Re: Addendum #1 to RFP 18-09 Farmstand Roof Replacement  
*Due date Change, Specification change(s)*

ADDENDUM ONE

HURLD-WYMAN SCHOOL SITE  
FARMSTAND ROOF REPLACEMENT  
Woburn, Massachusetts

DATE: 09 March 2018

**8**  
3.5.01  
**Kitchen Exhaust Fan Curb - Elevation**  
SCALE: 1 1/2" = 1'-0"

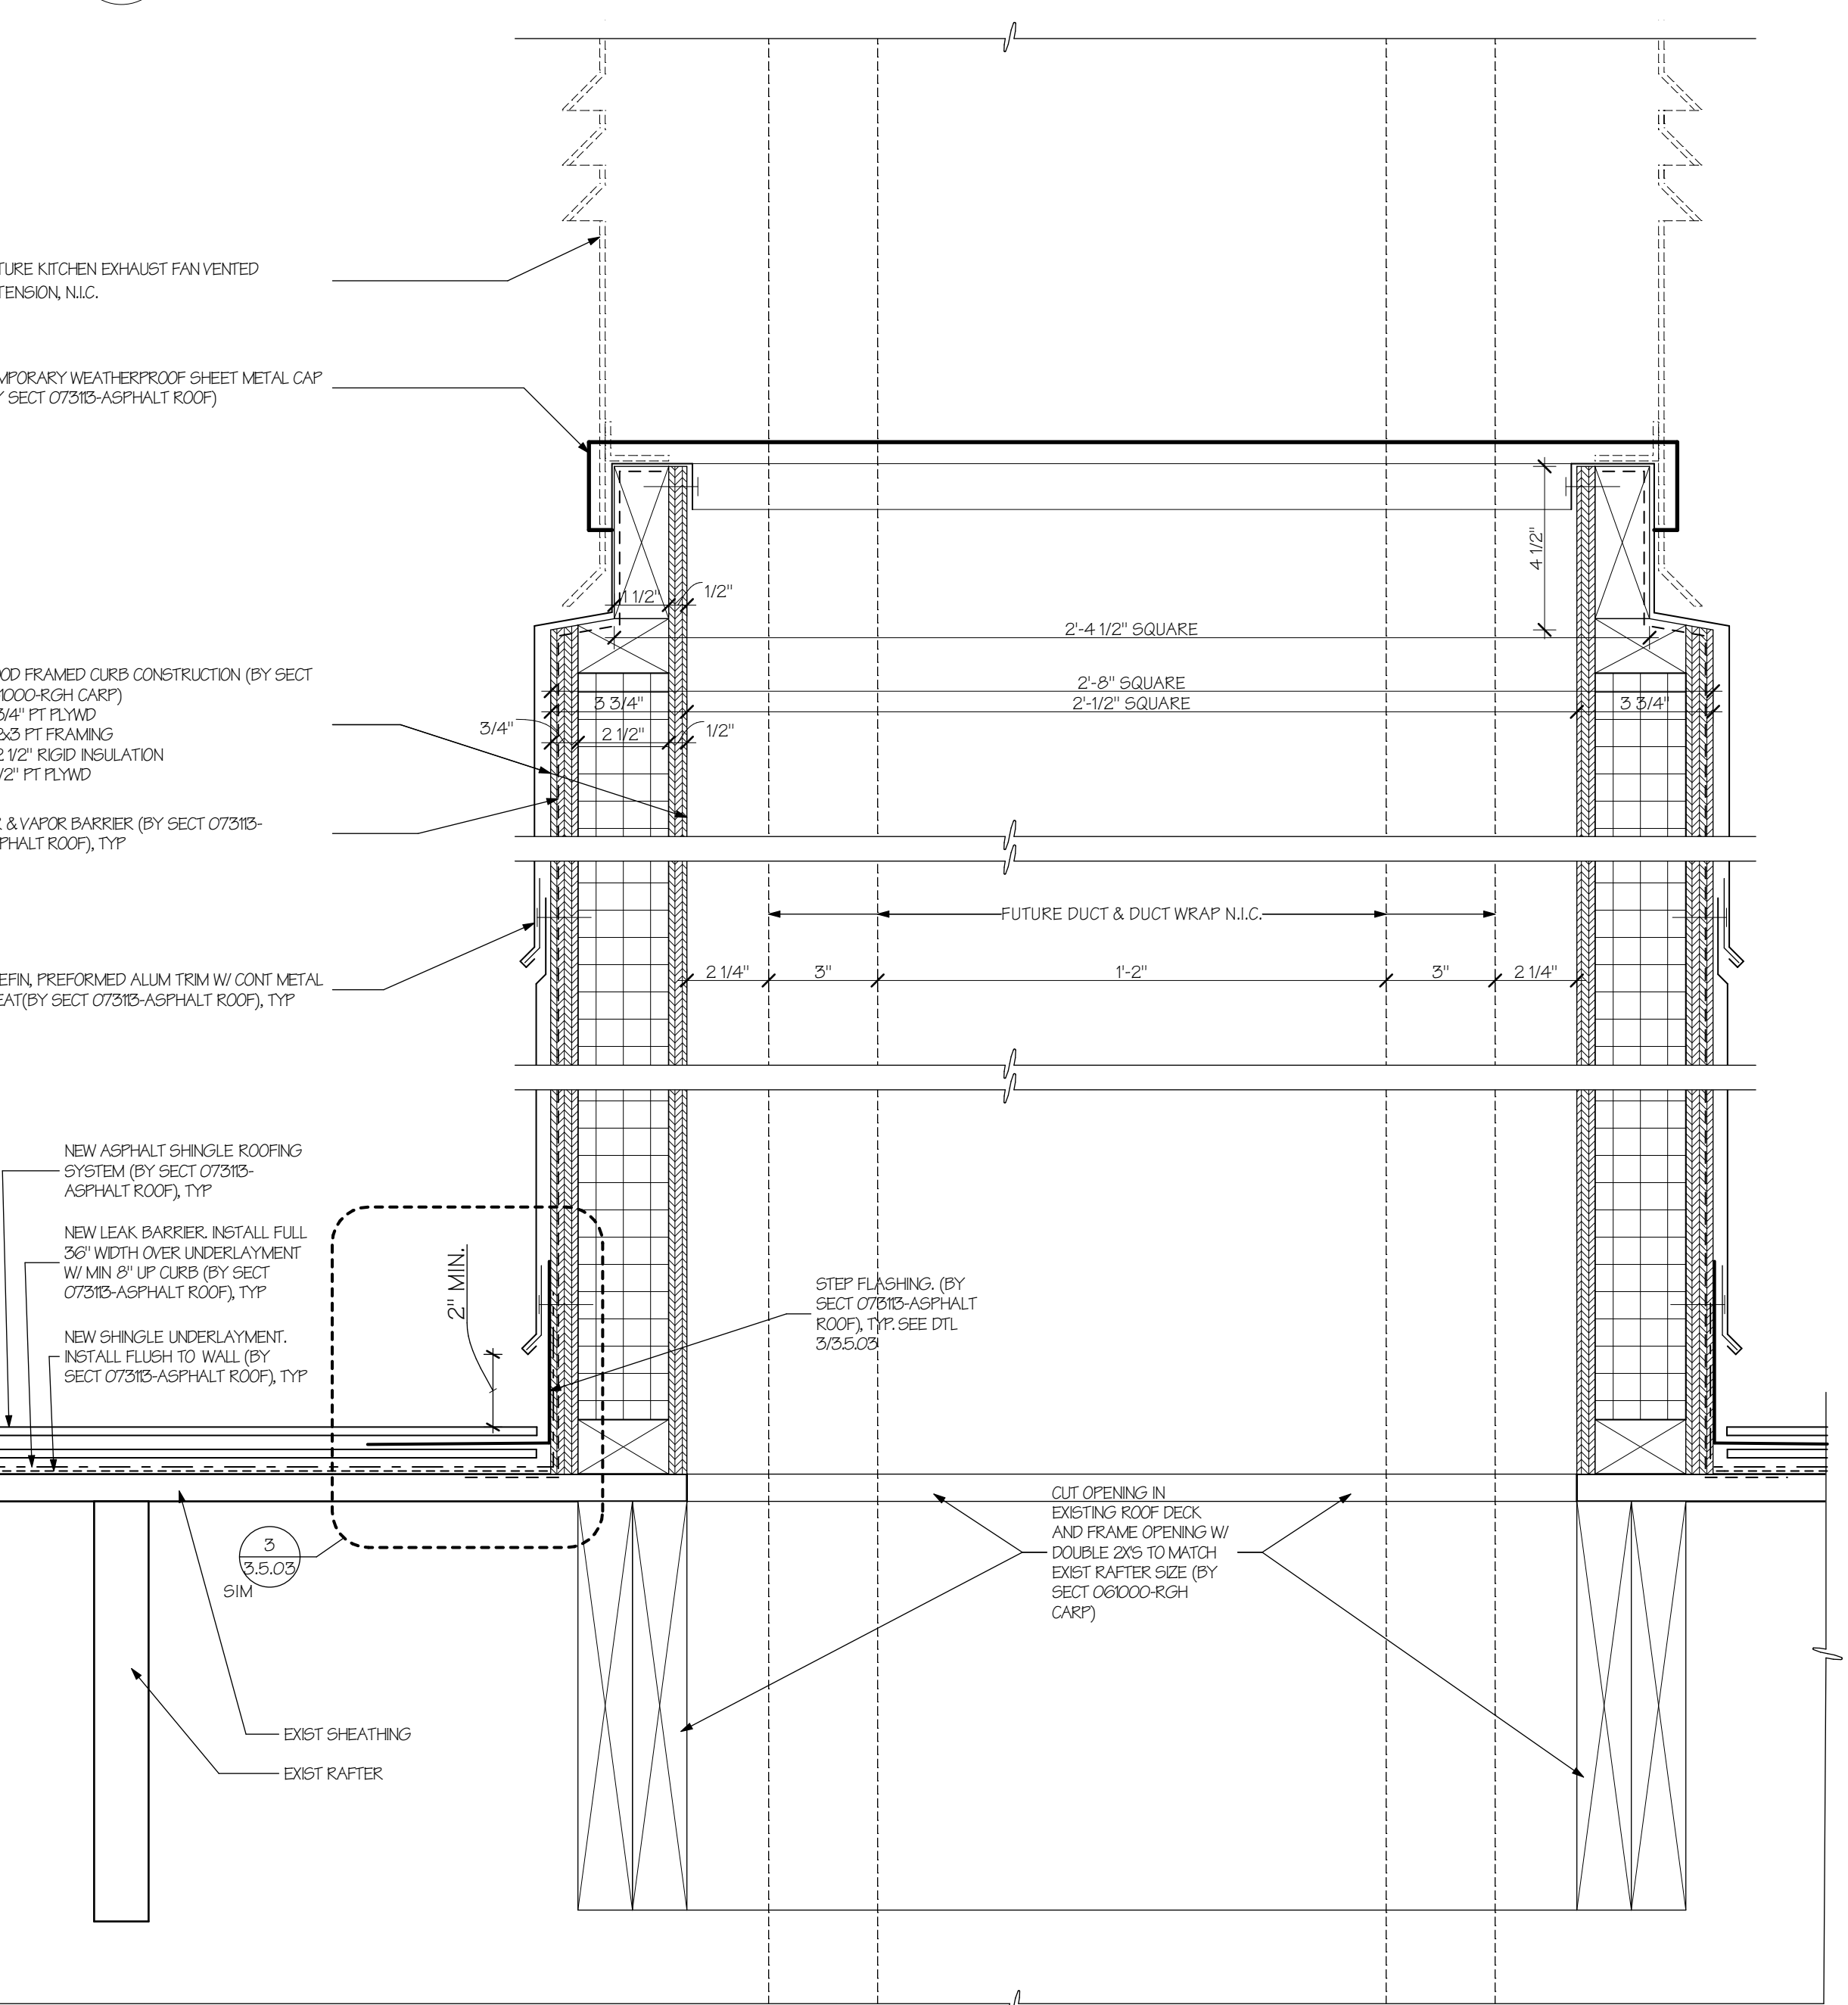
- a. Drawing 3.5.02 reissued with revisions to Detail 8 - Kitchen Exhaust Fan Curb - Elevation; Detail 9 - Kitchen Exhaust Fan Curb Section Detail; and new Detail 8A - Up Slope Curb Elevation, inserted.
